CITY OF SEASIDE
BOARD OF ARCHITECTURAL
REVIEW

CITY OF SEASIDE STAFF REPORT

SUBJECT: BOARD OF ARCHITECTURAL REVIEW NO. BAR-19-08: THE BOARD OF ARCHITECTURAL REVIEW WILL CONSIDER THE ADOPTION OF FINDINGS AND EVIDENCE FOR THE DENIAL OF A 277 SQUARE-FOOT SECOND STORY ADDITION TO AN EXISTING 1,022 SQUARE-FOOT, ONE-STORY SINGLE FAMILY DWELLING LOCATED AT 1740 DARWIN STREET IN THE RS-8 (SINGLE FAMILY RESIDENTIAL) ZONING DISTRICT (APN 012-762-026). THE PROJECT IS CATEGORICALLY EXEMPT CLASS 1, SECTION 15301(E)(1) FROM THE CALIFORNIA ENVIRONMENTAL QUALITY ACT. ITEM HAS BEEN CONTINUED FROM THE AUGUST 7, 2019 BAR MEETING.

LANCASTER
RESIDENCE
ADDITION

3 EXISTING SOUTH ELEVATION
SCALE: 1/4"=1'-0"

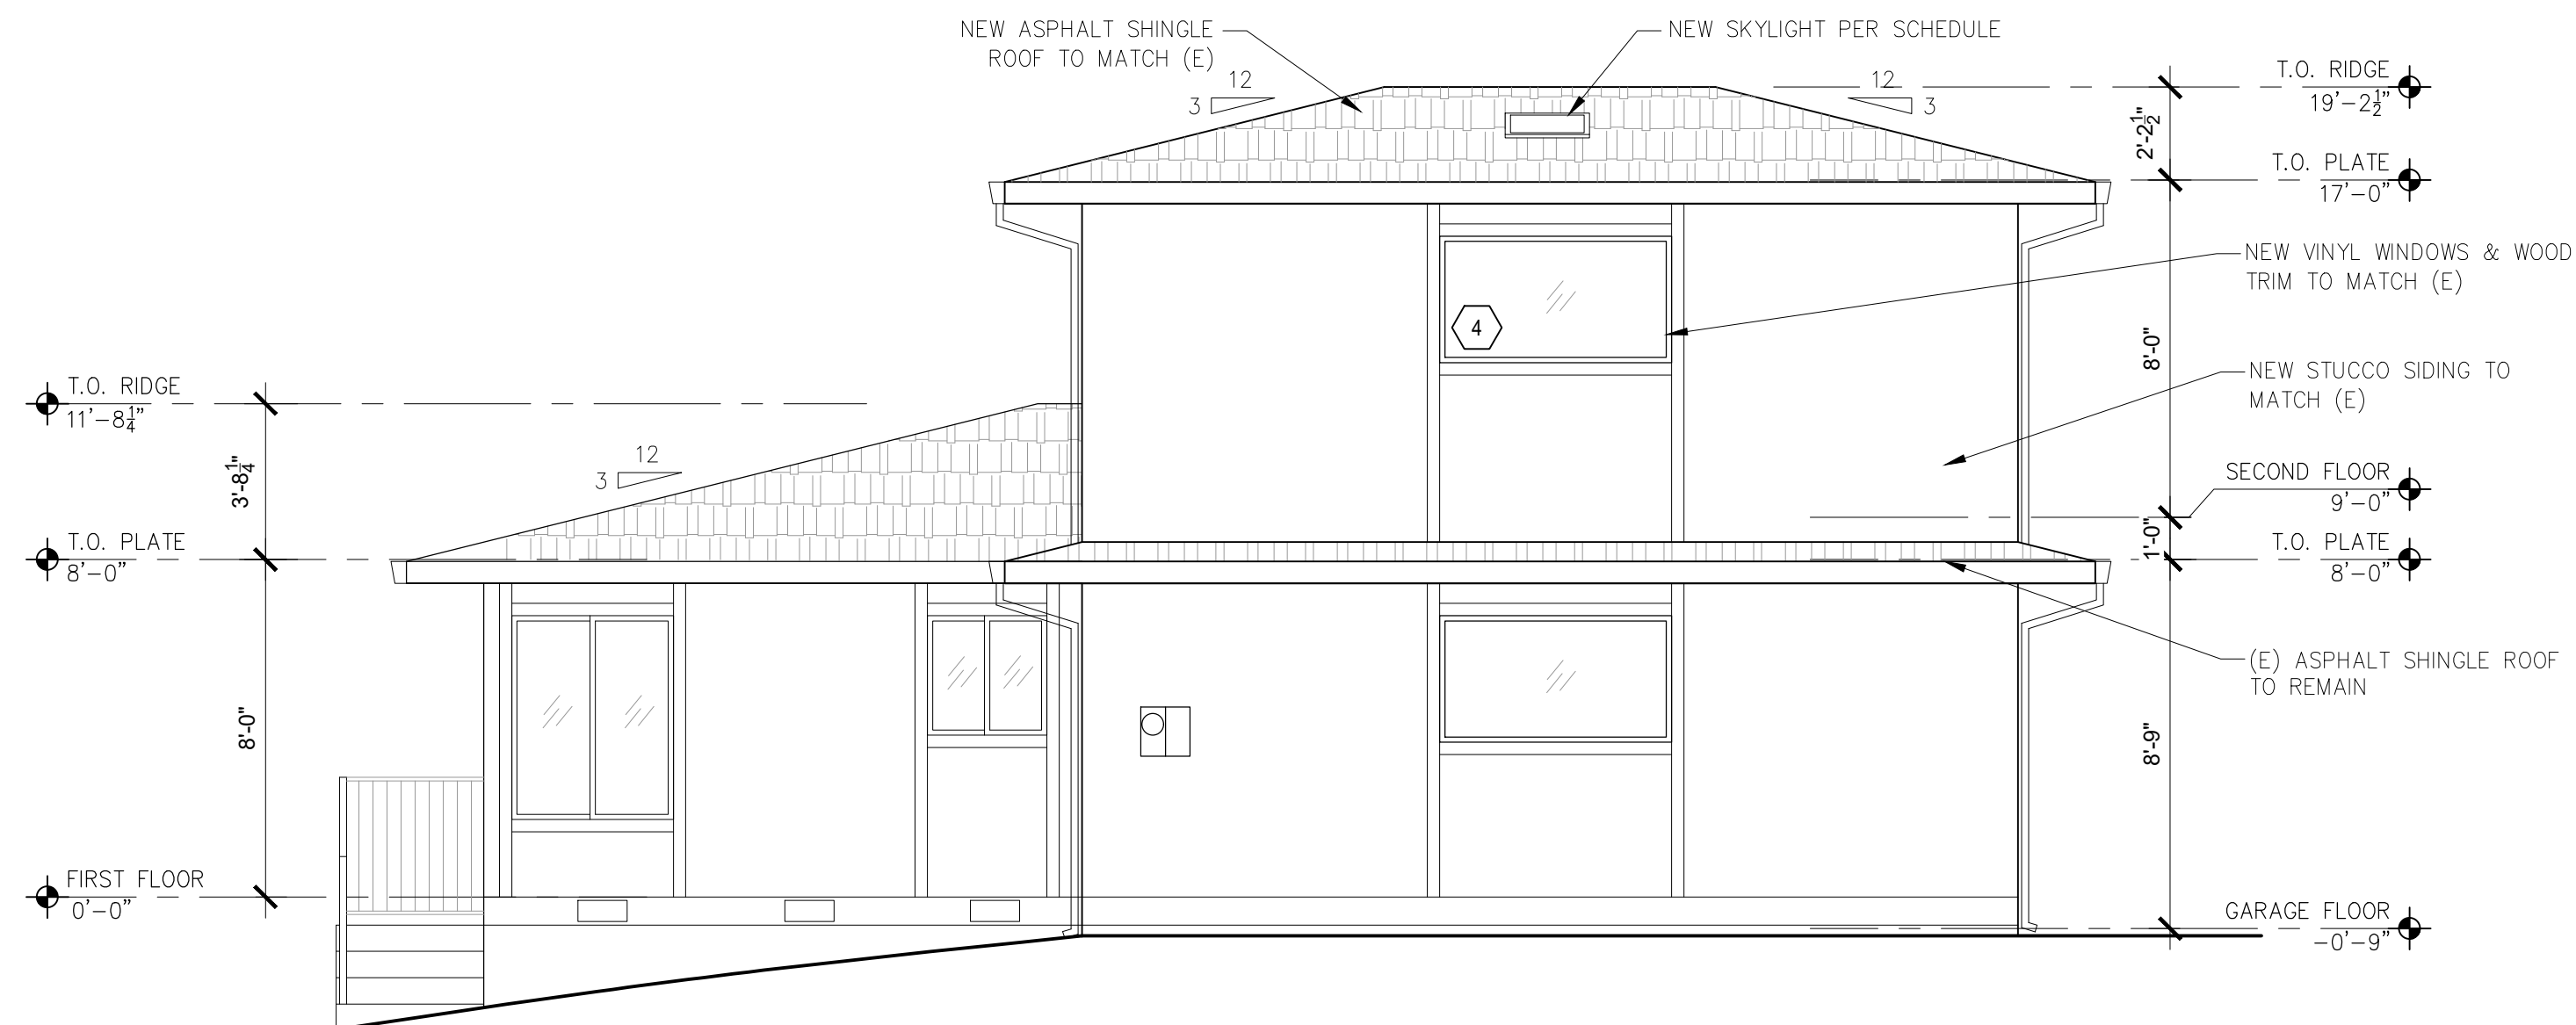
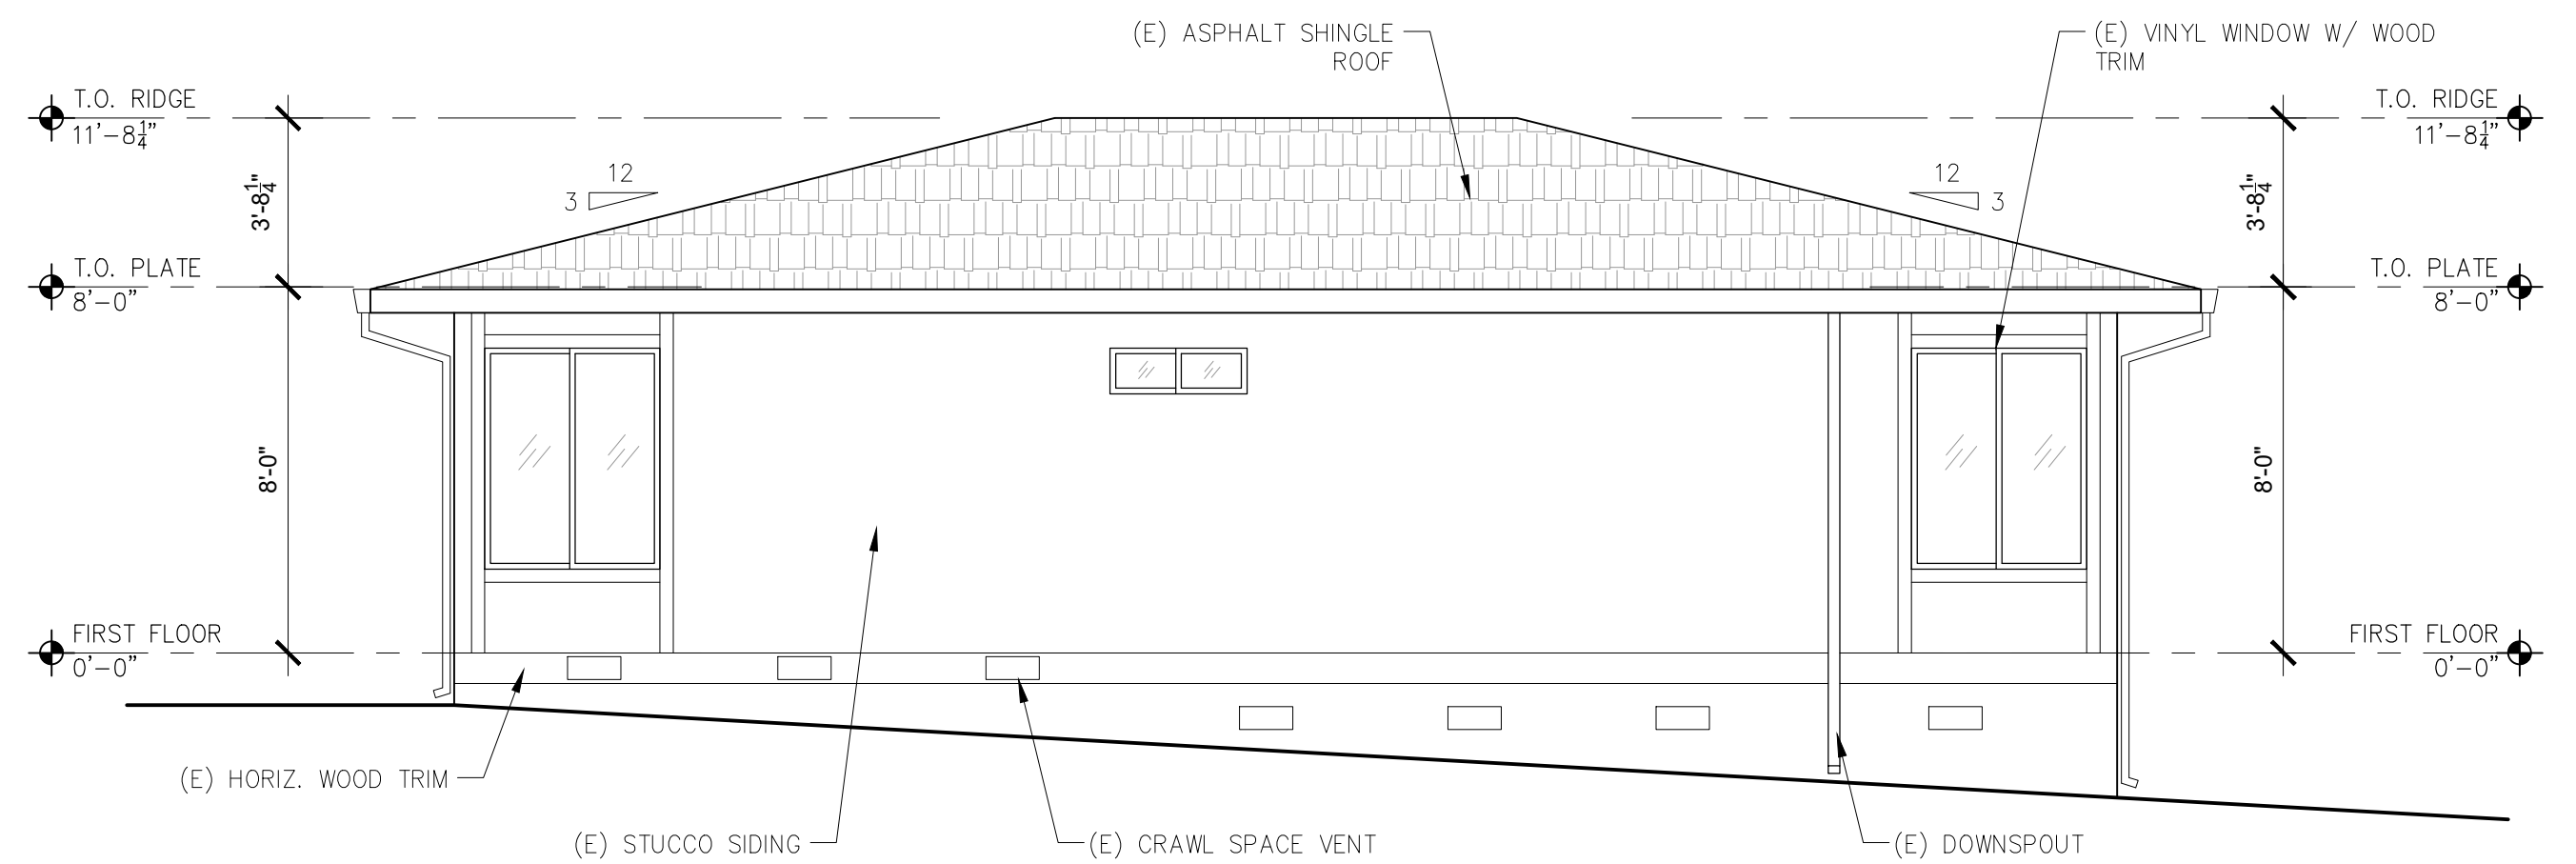
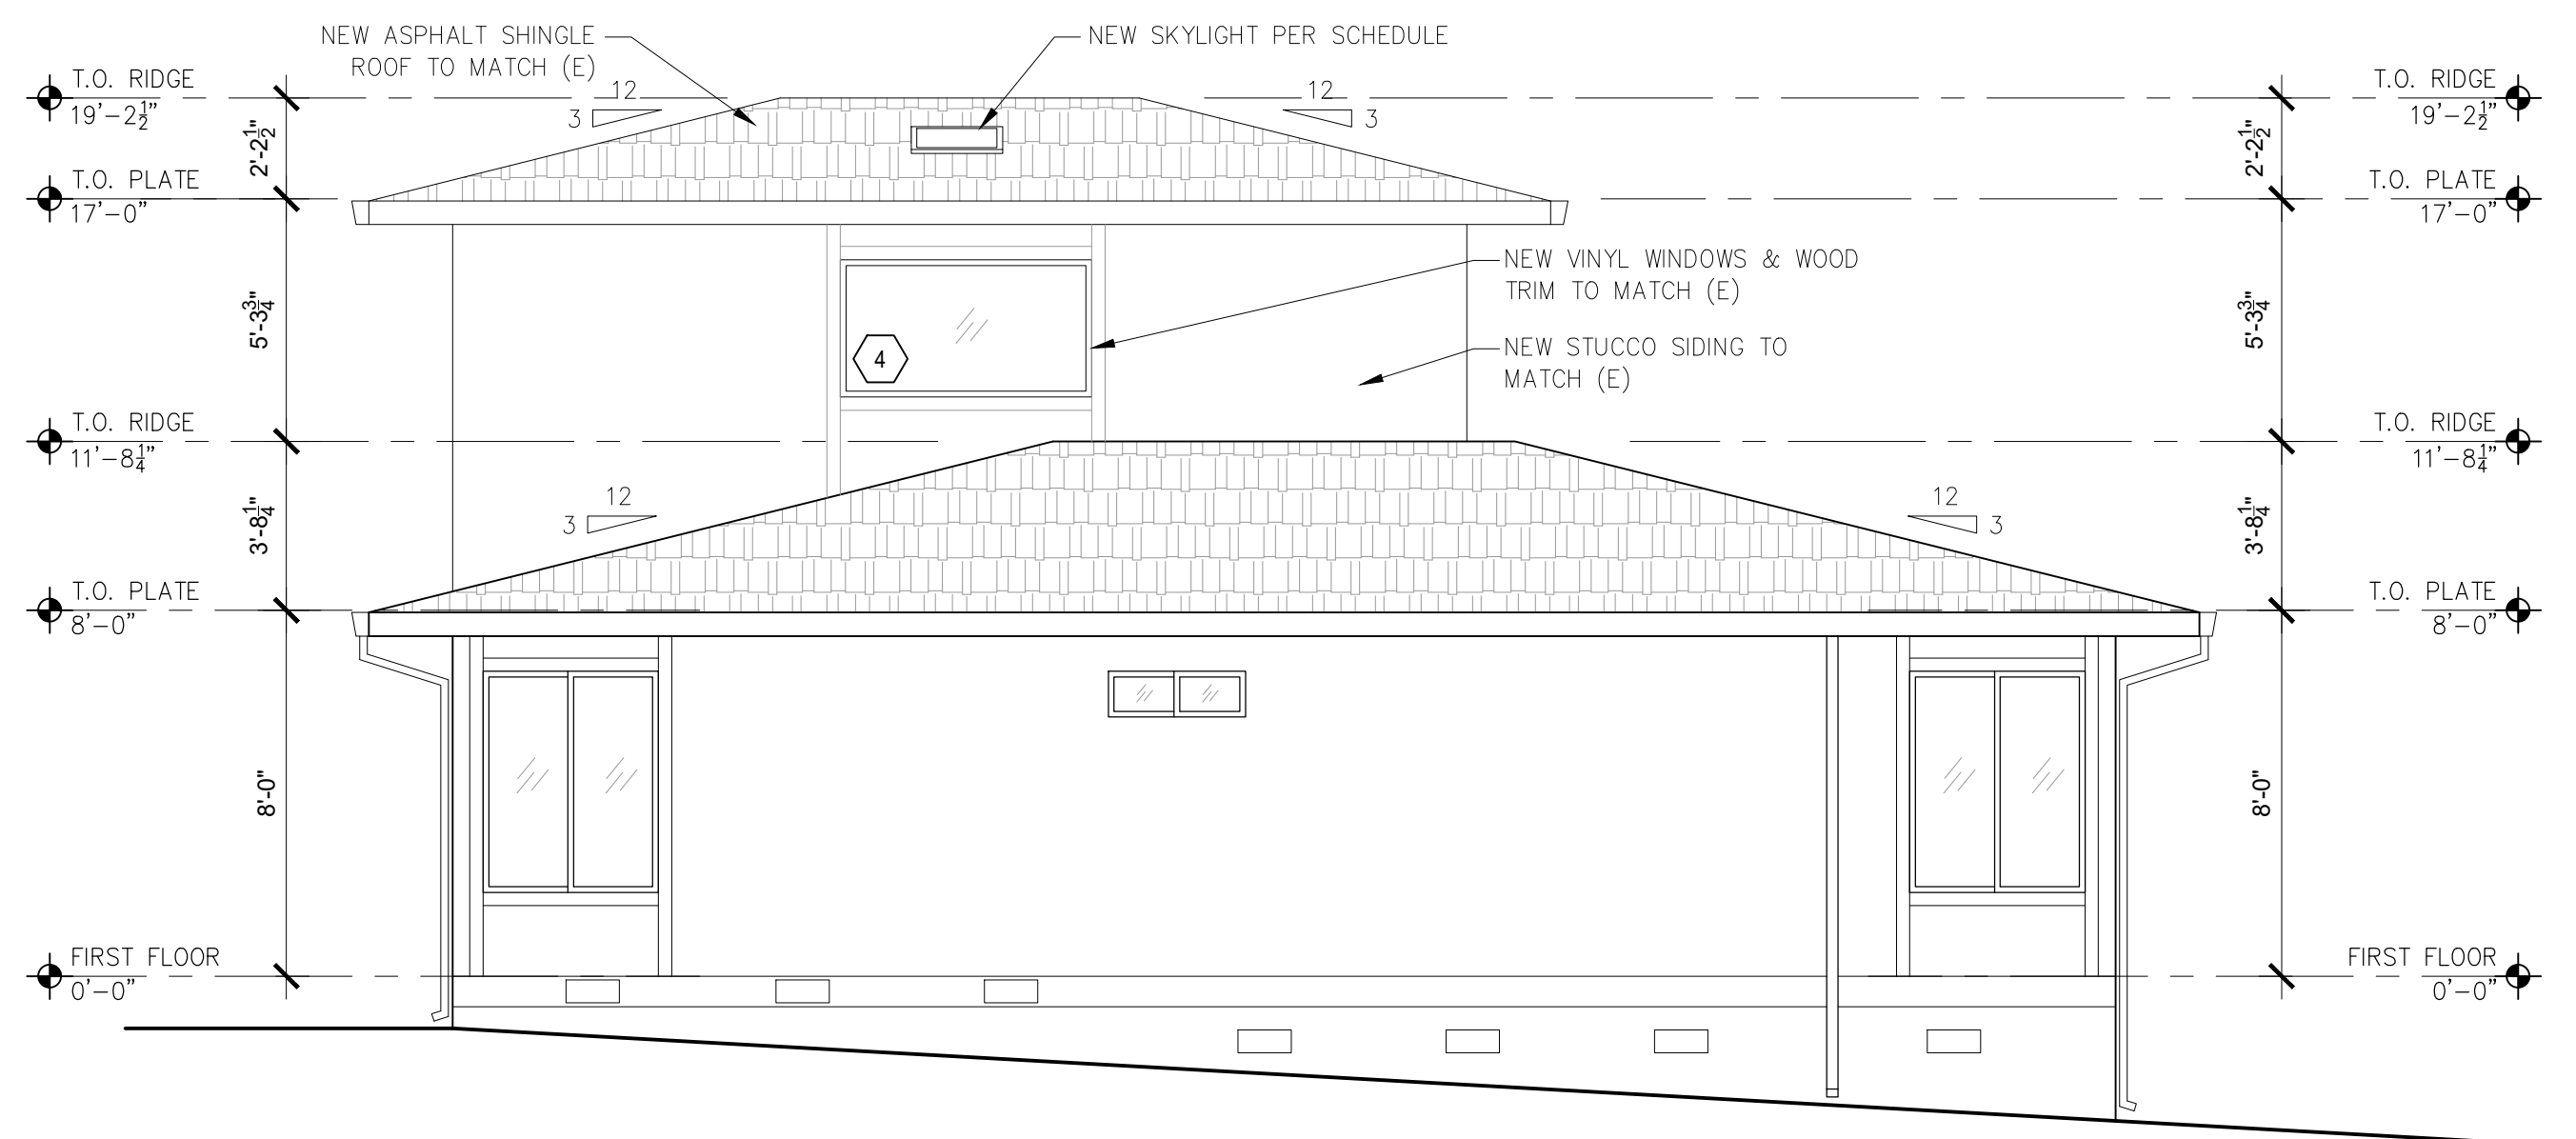
Evidence: The proposed second story addition would establish an inappropriate usage of mass and scale by offsetting the addition over the far south side of the dwelling and lacking offsets from the front and south side setbacks to create an articulated elevation on all sides.

Evidence: The existing dwelling is of sufficient size and area to accommodate a second story addition that could be repositioned more toward the center and north side of the dwelling to create an appropriate transition.

Evidence: The scale and mass of the second story addition would create an unbalanced pop-

up over the south side of the dwelling that would create an unbalanced appearance that is out of scale with the massing over the dwelling and therefore detracts from its architecture and visual appearance from the adjoining neighborhood.
